Amendments To Local Plan:

S/RRA/H Land at Highfields (phase 2), Caldecote

The local plan for S/RRA/H Land at Highfields (phase 2), Caldecote should be amended to account for both factual errors and alignment with previous planning applications for this site if this land is retained within the local plan.

Corrected site map

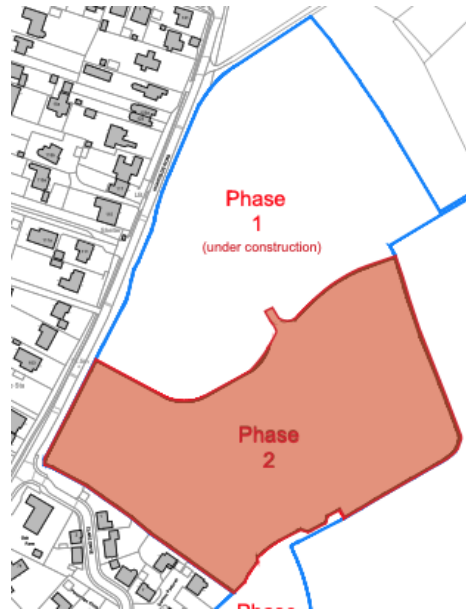
This site plan is incorrect as it includes land already under construction as part of Linden Phase 1.

In the map below (taken from the 'Design & Access Statement Land East of Highfields Road Highfields Caldecote - Phase 2') submitted by Linden Homes as part of application 21/02265/FUL the undeveloped land is red, marked as Phase 2, in the map below and has an area of 2.6 Ha.

- Current site area to 2.6 Ha
 - The corrected site area taken from map revision (see above).
- Addition 'and on south-west boundary (boarding Clare Drive).'
